DOCUMENT CHANGE REQUEST

DCR number 400	Changes required for: General	Originator: Steve Thacker - ESCC
Date: 2008/06/10	Date sent: 2008/06/10	Organisation: ESA/ESTEC
Status: IMPLEMENTED

Title:	Generic Specification for Integrated Circuits Monolithic		
Number:	9000	Issue:	4

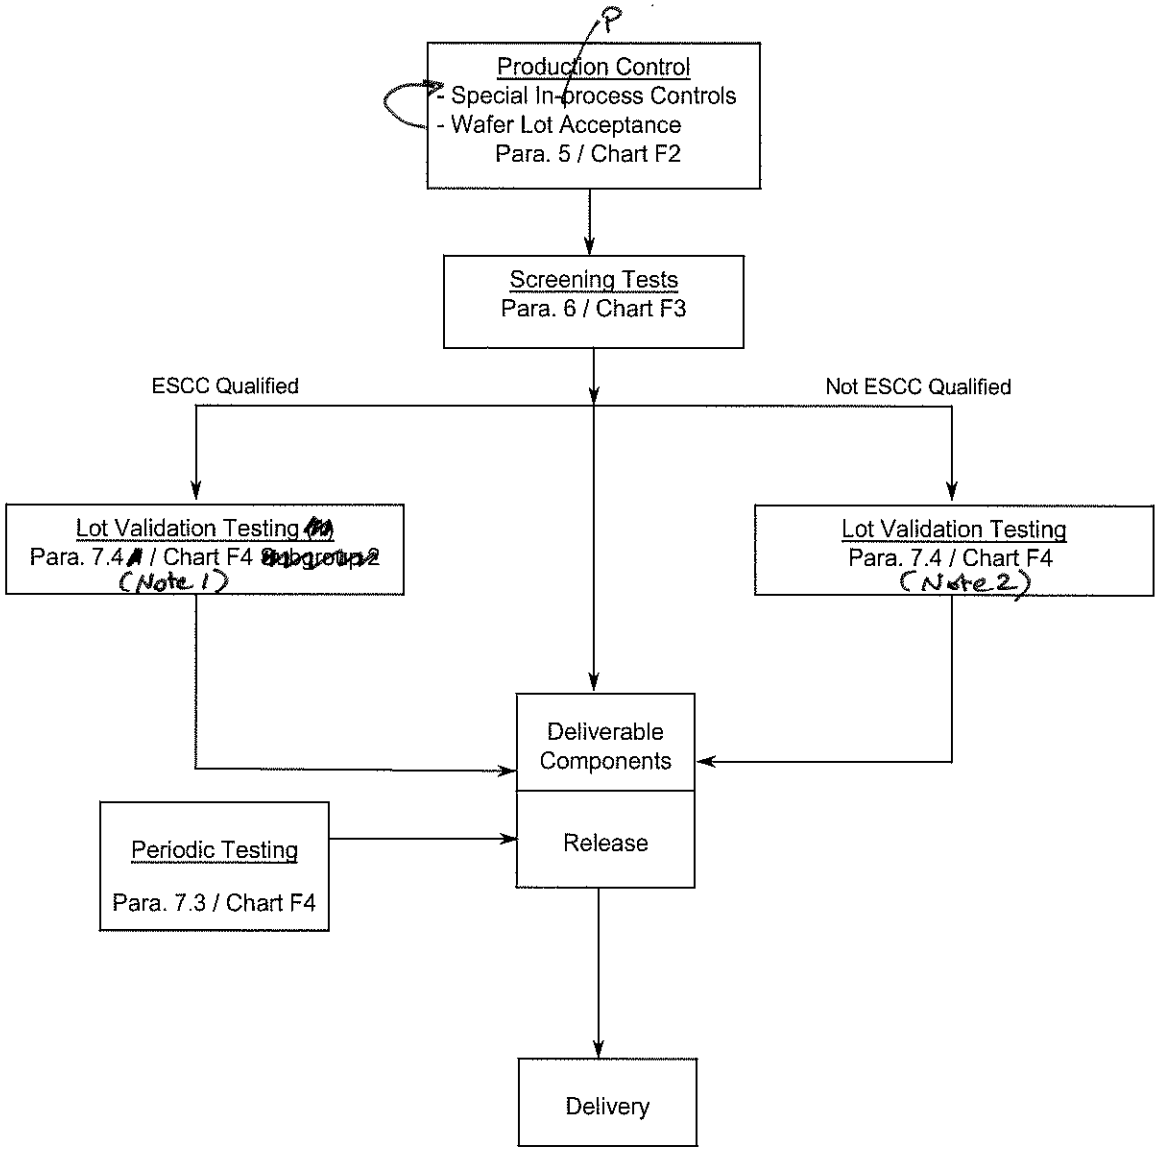
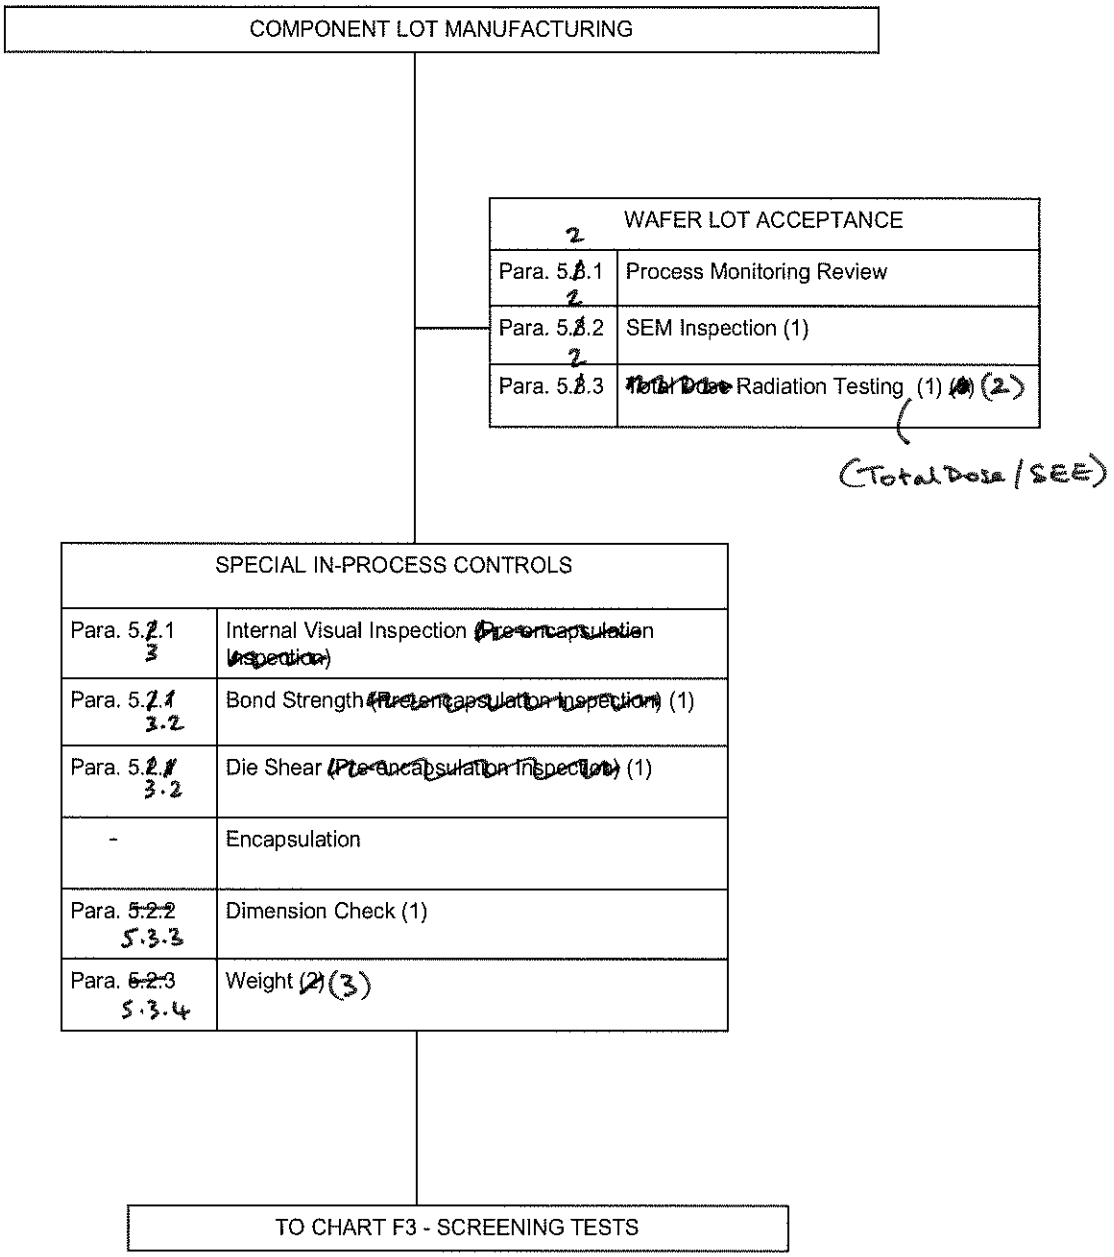
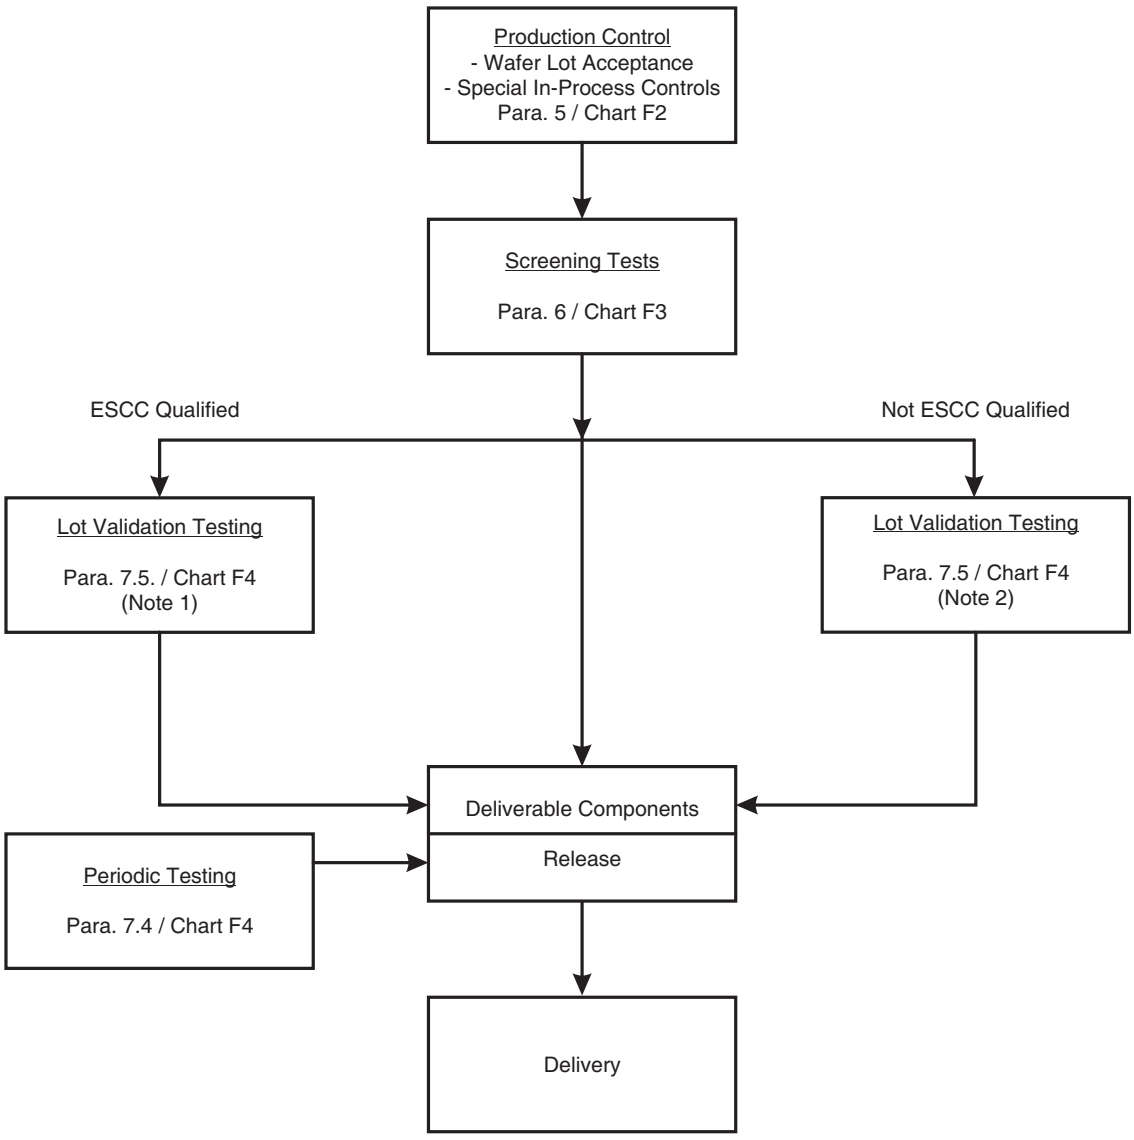
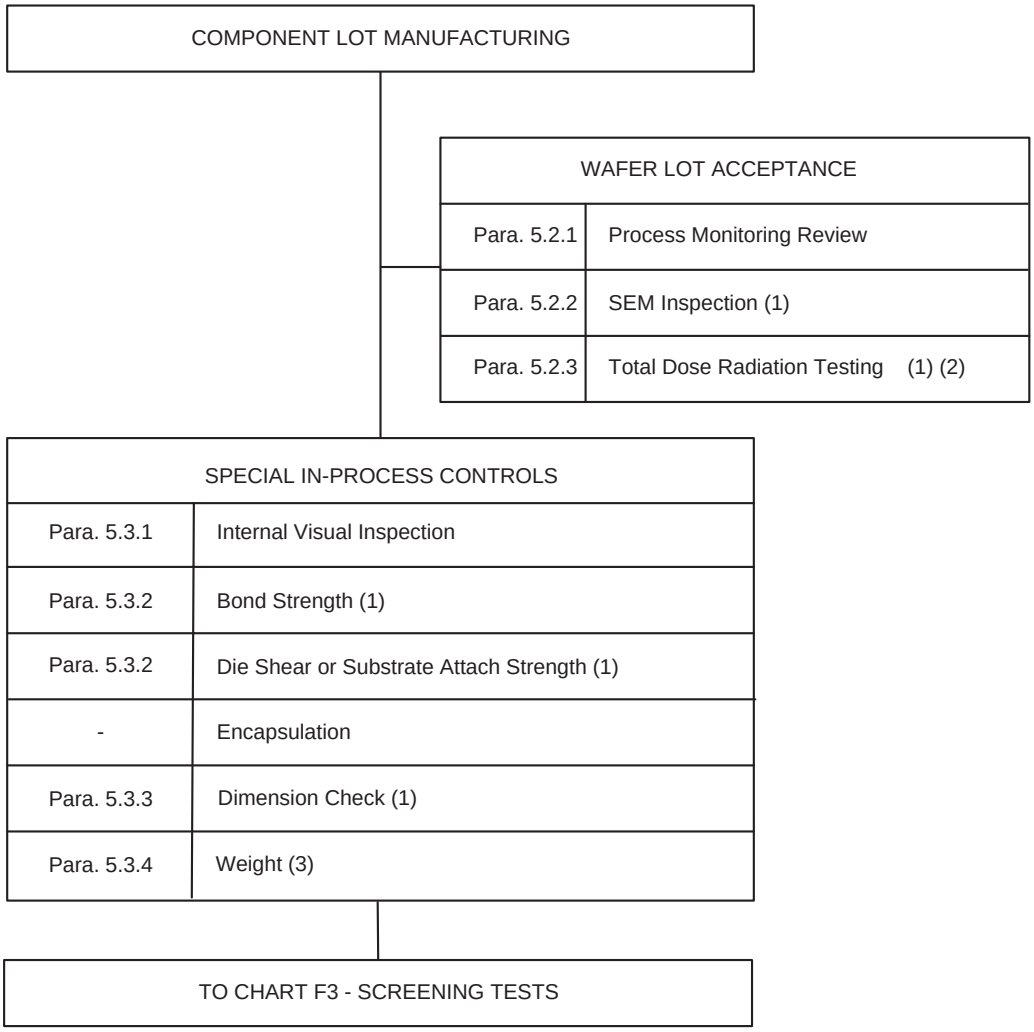
53 Page 24 Chart F1
Change the order of items in the top box to be:

Under "Not ESCC Qualified" renumber as Para. 7.5 and add "(Note 2)" in the Lot Validation Testing box.

Add new Note 2 as follows:
"2. For unqualified components the need for Lot Validation Testing shall be determined by the Orderer and the required testing shall be as stipulated in the Purchase Order (ref. ESCC Basic Specification No. 23100)."

53 Page 25 Chart F1, Notes 1 & 2 are added to both LVT boxes to clarify in this overview that LVT is only performed if stipulated by the Orderer in the PO.

12.2 CHART F2 - PRODUCTION CONTROL

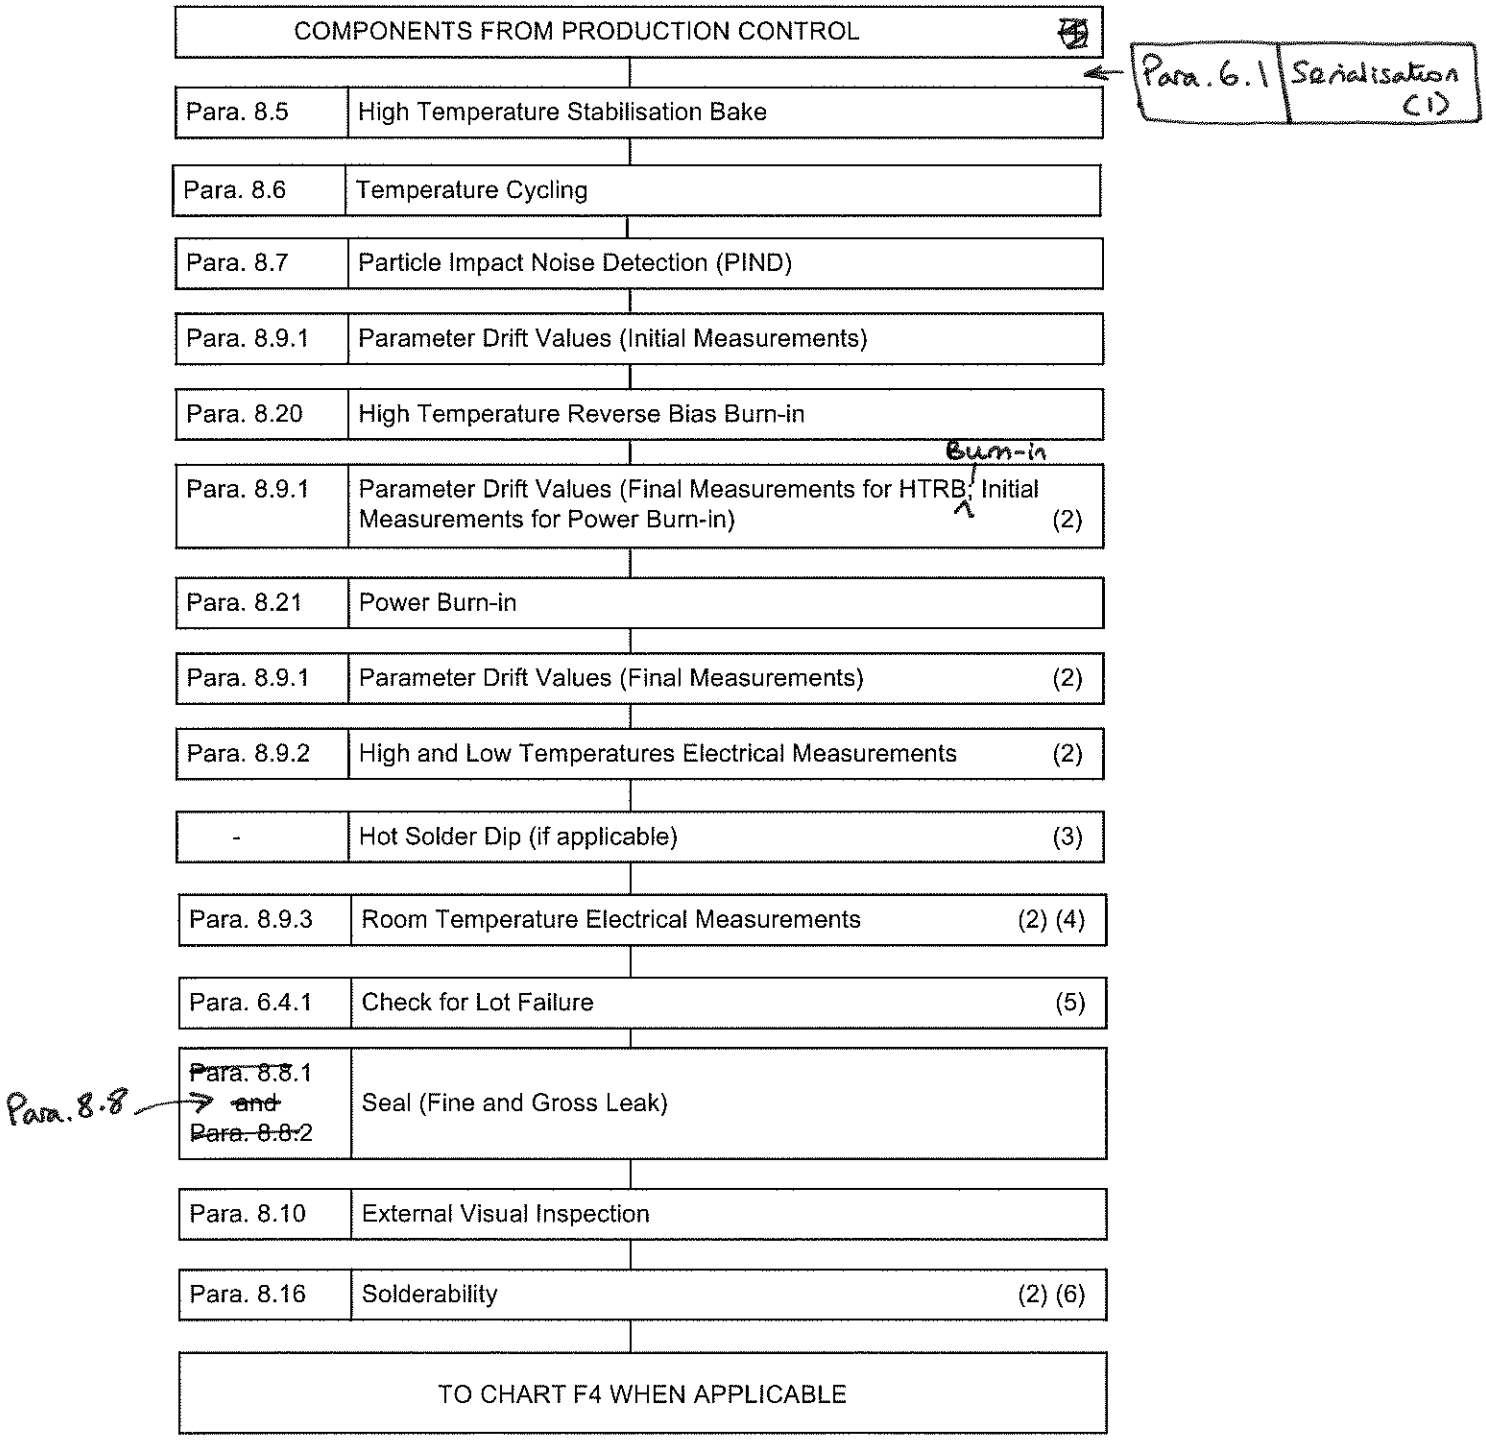
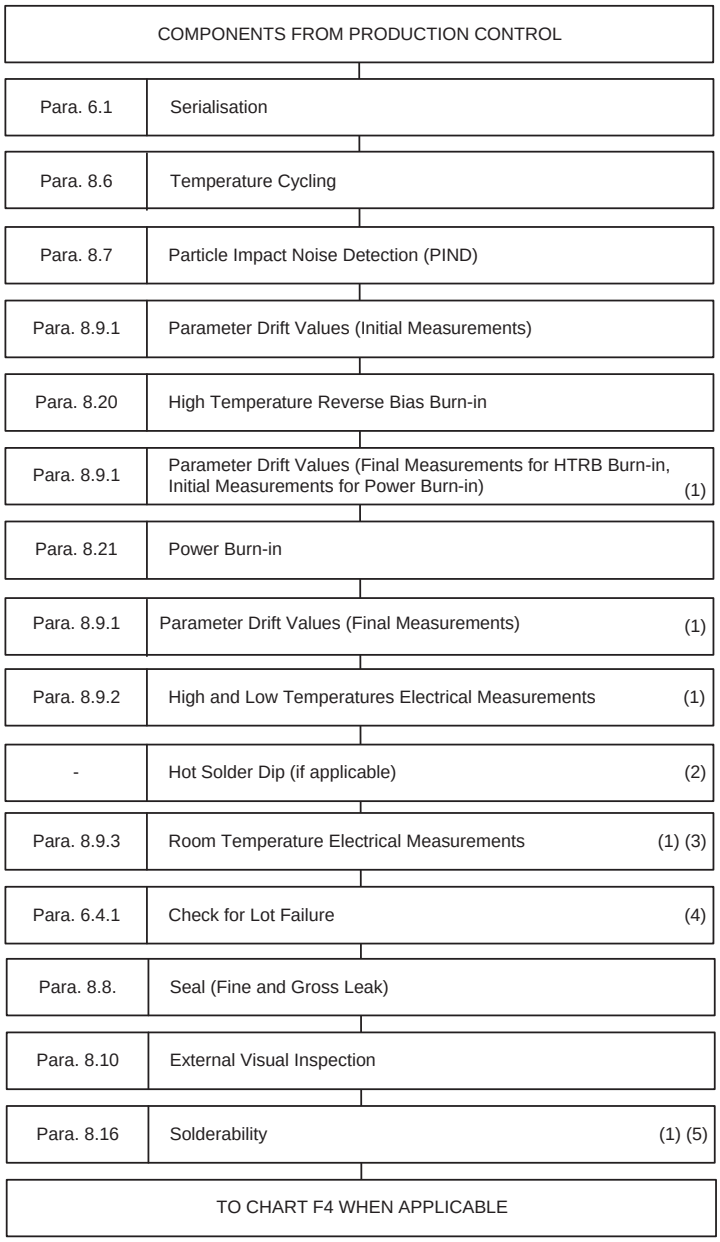
Delete from the first 3 boxes under Special In-Process Controls: "(pre-encapsulation inspection)"

In Note 3 replace "required" by "stipulated"

54 Page 26 Chart F2, As Wafer Lot Acceptance is performed prior to Special In-Process Controls the sequence & Para numbering is changed accordingly for clarification. Change items affected: 4, 9, 12, 44, 48, 49, 50, 53, 54

12.3 CHART F3 - SCREENING TESTS

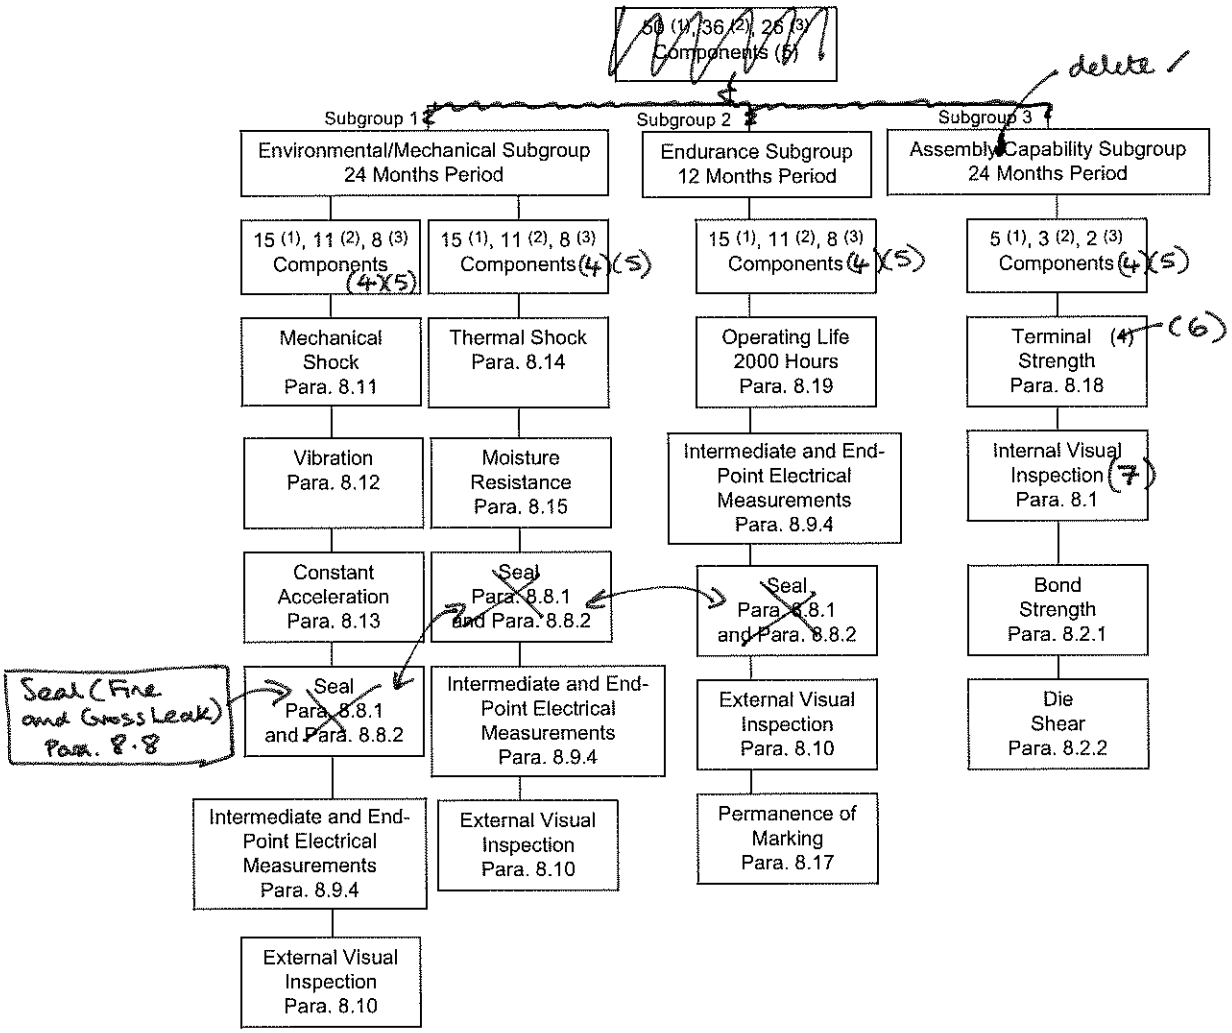
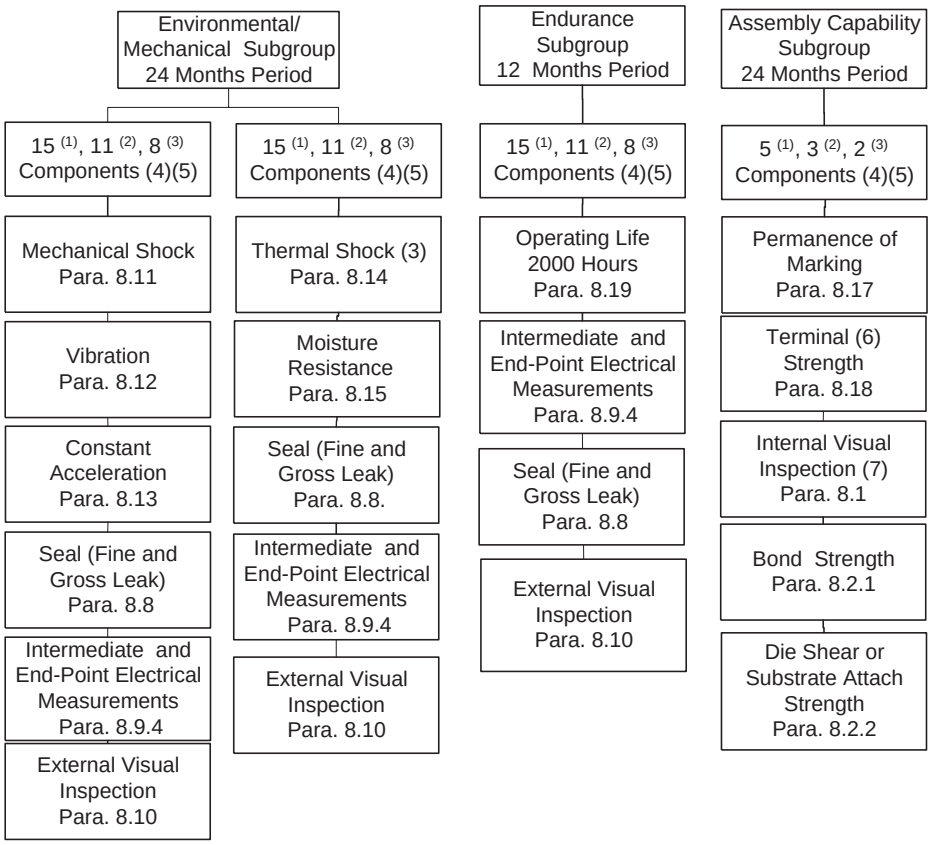
55 Page 26 & 27 Chart F3
Add new 2nd box:
"Para 6.1 Serialisation"

Delete note 1 and renumber other notes accordingly.

In 14th box delete "Para 8.8.1 and Para 8.8.2" and replace by "Para 8.8"
